DESIGN REVIEW/CERTIFICATE OF APPROPRIATENESS

Project/Property Address or Location: 6579 Taylor Rd.		Project Name/Business Name Eastgate Commercial Park		
Parcel ID No.(s): 027-000008-00	Zoning Designation: OCT	Total Acreage: 7.6		
Please check all that apply:				
SITE PLAN <input checked="" type="checkbox"/>	LANDSCAPING <input checked="" type="checkbox"/>	BUILDING DESIGN <input checked="" type="checkbox"/>	DEMOLITION <input type="checkbox"/>	OTHER <input type="checkbox"/>
Project Description: Two 21,000sf Flex industrial buildings. Three 8,520sf Flex industrial buildings.				
APPLICANT Name -do not use a business name: Robert LeVeck		Applicant Address: 1500 W. Third Ave. Ste. 120 Columbus, OH 43212		
Applicant E-mail: rleveck@leveckconstruction.com		Applicant Phone No.: 614-582-4765		
BUSINESS Name (if applicable):				
ADDITIONAL CONTACTS Please List Primary Contact for Correspondence (please list all applicable contacts)				
Name(s):		Contact Information (phone no./email):

Attn: Kelly Wicker, Administrative Assistant
RE: Project 6579 Taylor Rd Design Review Comment Letter Submittal 2
Project 6579 Taylor Rd Final Development Plan Comment Letter Submittal 2

PLANNING AND DEVELOPME

A LANDSCAPE PLAN
SCALE: 1"=40'-0"

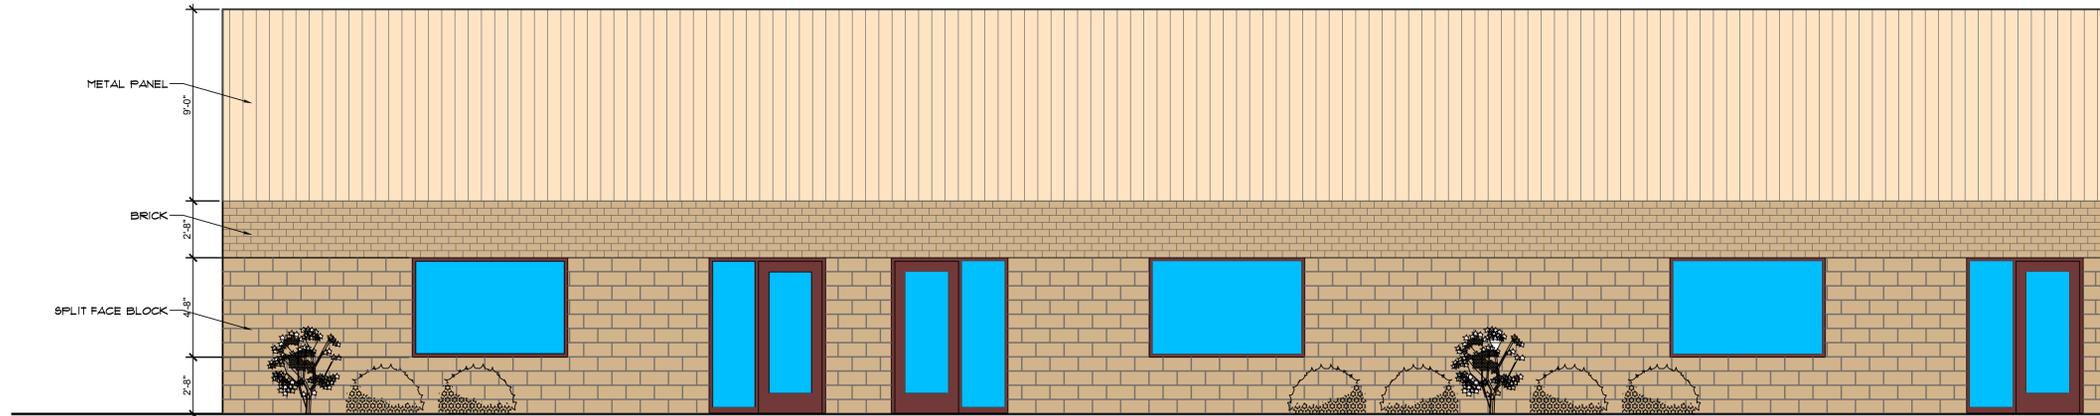
8. The landscape plan needs to calculate the parking area (spaces and drive aisles). The square footage of required landscape islands is 5% of the parking area. 1 tree per 100 square feet of required landscape island is required. The minimum tree caliper size is 3". Please revise the landscape plan for this calculation and increase the minimum tree caliper size.

8/20/19 - Based on the data provided, 46 trees need to be planted in the parking area, it appears that only 32 trees are planted. An additional 14 trees are required. Please revise accordingly.

9. The landscape plan shows barberry bushes at 24" in height planted along the parking area. No issues with barberry being planted as it is considered an evergreen, however, the minimum height is 36". Please revise accordingly.

8/20/19 - The landscape plan was revised to indicate that the parking lot screening will be accomplished by "Clethra Alnifolia". This bush is not an evergreen and therefore doesn't meet the requirements of the code. Additionally, the labeling on the landscape plan still indicates a planting size of 24". Please revise accordingly.

10. Chapter 914 requires one tree inch to be planted per 1,000 square feet of impervious surface. This requirement is in addition to any other planting requirements. Please revise the landscape plan accordingly.

8/20/19 - The landscape plan does not appear to have been revised. Please add to the table some indication of the requirements and the plantings or preserved trees that meet this requirement.

RESPONSE: We show the calculation for the 5% parking area as required landscape islands. Further we have added additional trees to the landscape islands, 4 per island of 355+/-SF and 2 per island of 167 +/-SF. These are shown as 3" caliper trees.

RESPONSE: We have revised this to Chinese Juniper

RESPONSE: Additional trees have been added. Existing trees to remain has been taken into account in determining the number of trees, at 2.5" per code, that have been required.

BUILDING 4&5 FRONT ELEVATION

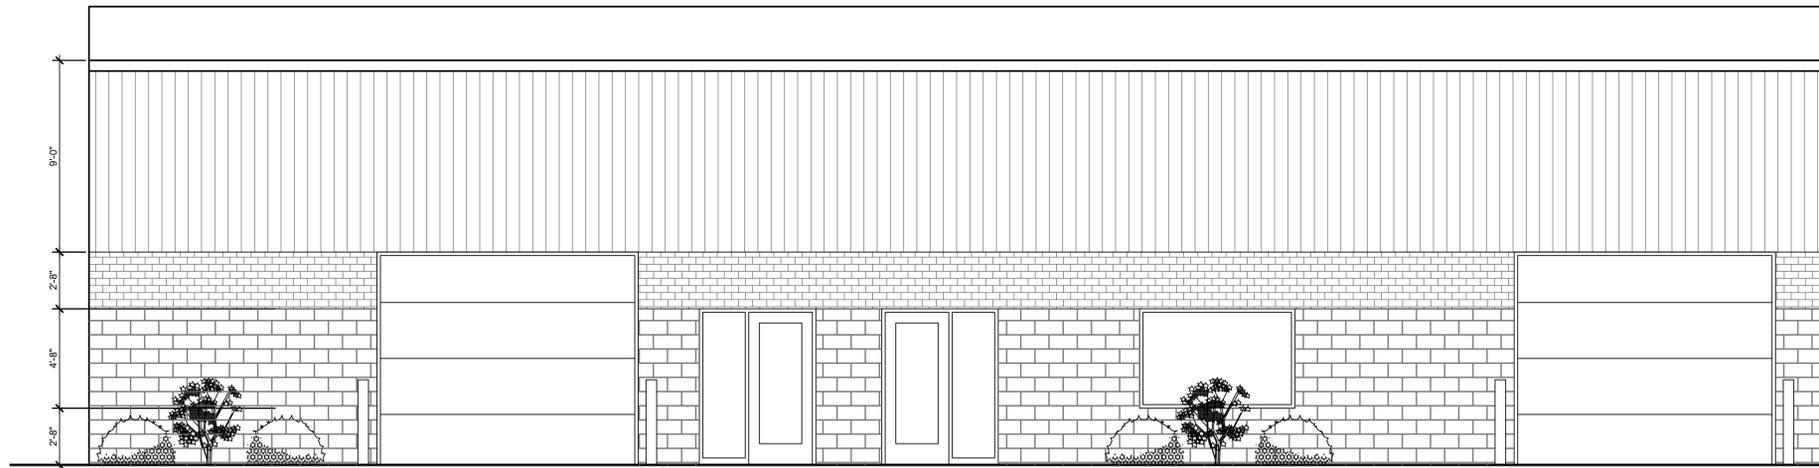
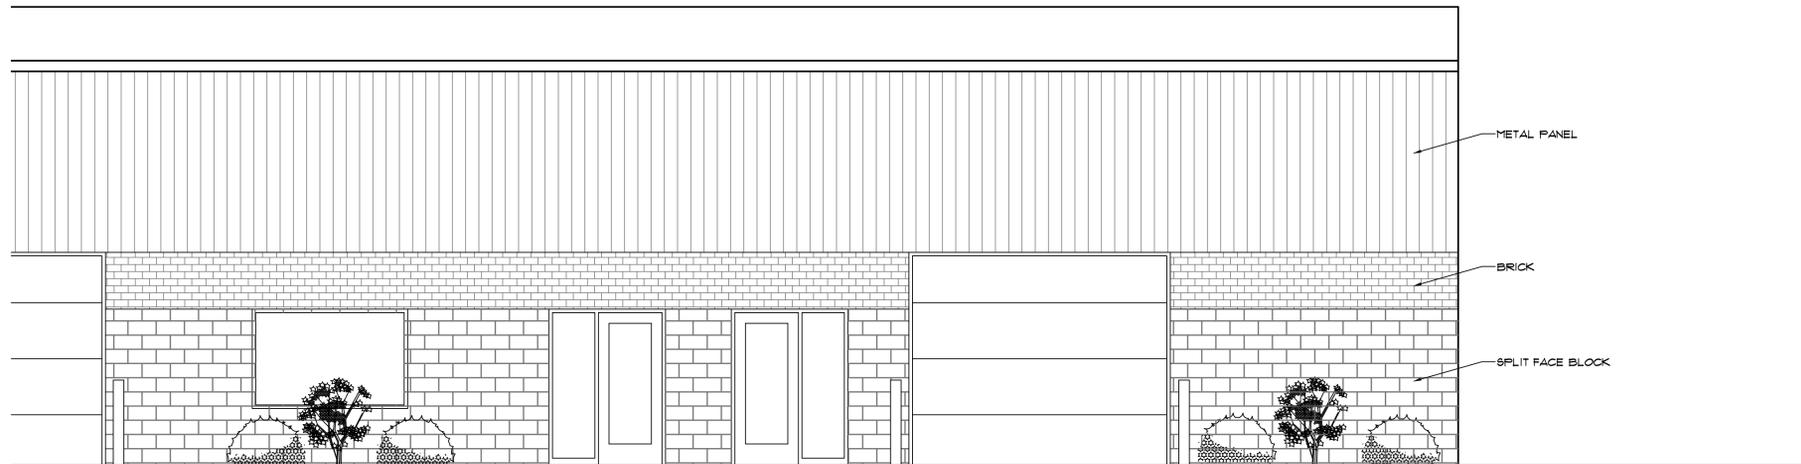
12. 8/20/19 - *The revised elevations depict a loading dock on the front elevation (see sheet A3.07). Chapter 1155.04(e)(3)(A) prohibits loading docks on the front elevation. Please either revise the elevations or the variance application.*

RESPONSE: Sheet A3.07 (now A3.08) reflects the Front Elevation of Buildings 4&5. This elevation faces internal to the site and not to a public way or adjacent parcel. The label “Front Elevation” is merely an architectural convention for labeling the elevations of a building and does not reflect “Street Frontage Elevation”, or Main Façade, which is what Chapter 1155.04(e) is addressing.
